Board of Architectural Review (BAR) Conservation District - Certificate of Appropriateness

Deadline for submittals is Tuesday 3 weeks prior to next BAR meeting by 4 p.m.	
Project Name/Description Summit House	
Address/Location 703 Rugby Rd,	Charlottesville Van
Owner Name TJMU Church	_Applicant Name_Dennis Harris
Applicant Information Address: ZIO Cav I fon Pd Chavio Hesville Va Email: Dennis@ martinhorn.com Phone: (W) 220-7770 (B) 531-370 FAX: 220-7797 Property Owner Information (if not applicant)	Signature of Applicant I hereby attest that the information I have provided is, to the best of my knowledge, correct. (Signature also denotes commitment topay invoice for required mail notices.) Signature Date PATRICIA E Schoume 2-6-15
Address: 717 Rugby Rd	Print Name Date
Email: Trish@uucharlottesville.org Phone: (W) 293-8179 (H) FAX: Do you intend to apply for Federal or State Tax Credits for this project?	Property Owner Permission (if not applicant) I have read this application and hereby give my consent to its submission. G-2-15 Signature Date Print Name

RE: 703 Rugby Rd Summit house renovations and approvals

Metal Roofing Systems Color Availability

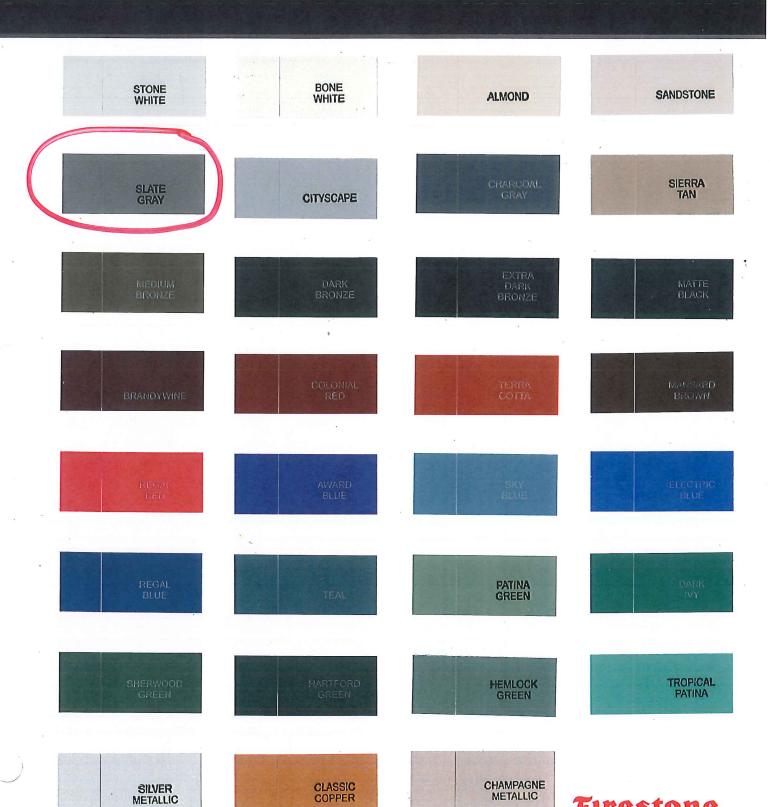
Englert colors Slate Grey or Dark Brown. Firestone Slate Grey (Will bring a sample with needed)
